## TSB - CAS02

Models applicable > Case 745S,844S,743XL,745XL,844XL,845XL  
Ag Clutch Part Number > 329 1001 CA-DCB

### CLUTCH PLATE REPLACEMENT

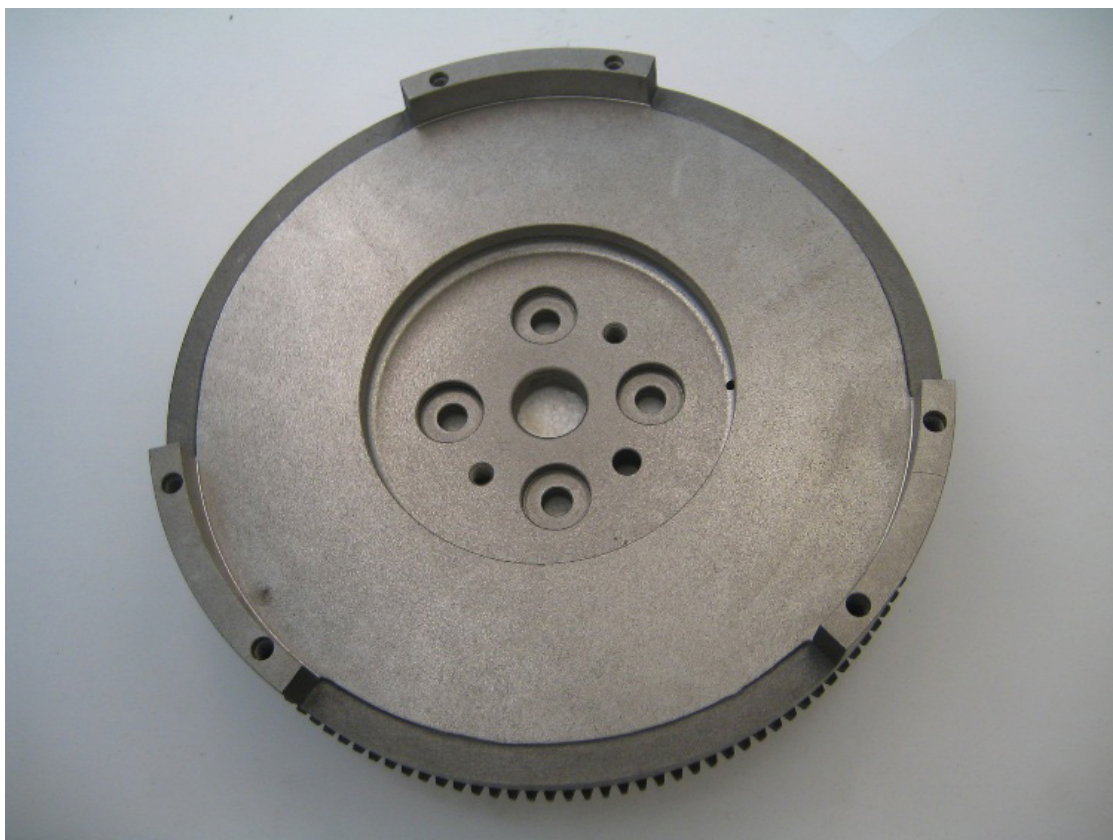
The clutch plate hub recess in the flywheel must be checked prior to installation of the clutch.

The flywheel rebate dimension in some models is only 165mm in diameter.

Failure to check and/or modify the flywheel may result in release problems, possible shudder or premature disc failure.

This must be increased to 170mm diameter X 3mm deep to allow clearance of the larger hub of the upgraded disc.
